Access Compliance Report

Public Rights-of-Way

Intersection ID: 10036062	Main Street: RIVERGATE_PY	Cross Street: N/A	Location: SW
ADA ID: D471A9E3AD81	Ramp Type: PerpDiag	Initial Pass/Fail: Fail	Overall Compliance: No
		Severity Score: 22.5

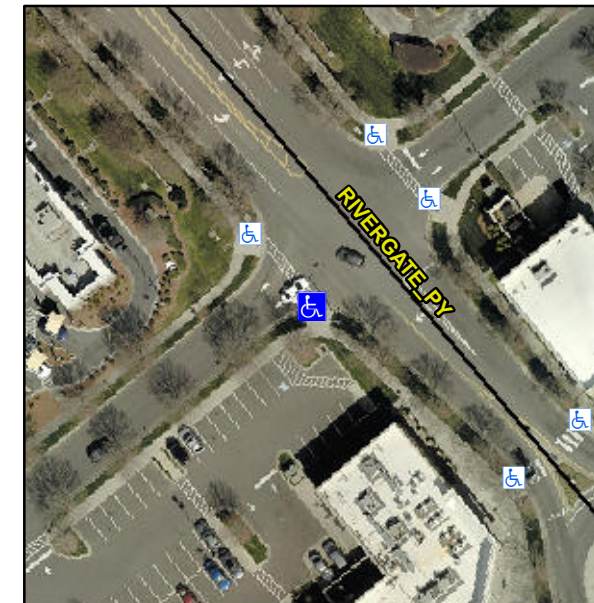
Not Found, R304.5.1, R304.2.2, R304.5.3

Compliance	Description	Data	Compliance	Description	Data
N/A	Ramp Length (in)	96.0	No	Ramp Slope (%)	8.6
No	Ramp Width (in)	41.0	No	Ramp XSlope (%)	3.2
N/A	Flare Type LT	N/A	N/A	Flare Type RT	N/A
N/A	Flare Slope LT (%)	N/A	N/A	Flare Slope RT (%)	N/A
N/A	Flare Traversable LT?	N/A	N/A	Flare Traversable RT?	N/A
N/A	Landing Length (in)	N/A	N/A	DWS Provided?	N/A
N/A	Landing Width (in)	N/A	N/A	DWS Contrast?	N/A
N/A	Landing Slope (%)	N/A	N/A	DWS Length (in)	N/A
N/A	Landing X Slope (%)	N/A	N/A	DWS Full Width?	N/A
N/A	Landing Curb? (Y/N)	N/A	N/A	DWS Offset (in)	N/A
N/A	Shared Landing?	N/A			
N/A	Gutter Ponding?	N/A	N/A	Gutter Slope (%)	N/A
N/A	Gutter Lip Ht (in)	N/A	N/A	Gutter X Slope (%)	N/A
N/A	Painted X Walk1?	No	N/A	Painted X Walk2?	Yes
	X Walk 1 Direction	To E		X Walk 2 Direction	To N
N/A	X Walk 1 Width (in)	N/A	N/A	X Walk 2 Width (in)	52.0
	X Walk 1 Slope (%)	0.1		X Walk 2 Slope (%)	0.6
	X Walk 1 X Slope (%)	0.6		X Walk 2 X Slope (%)	2.3

Remove & Replace Curb Ramp With Two New Directional Ramps or Equivalent.
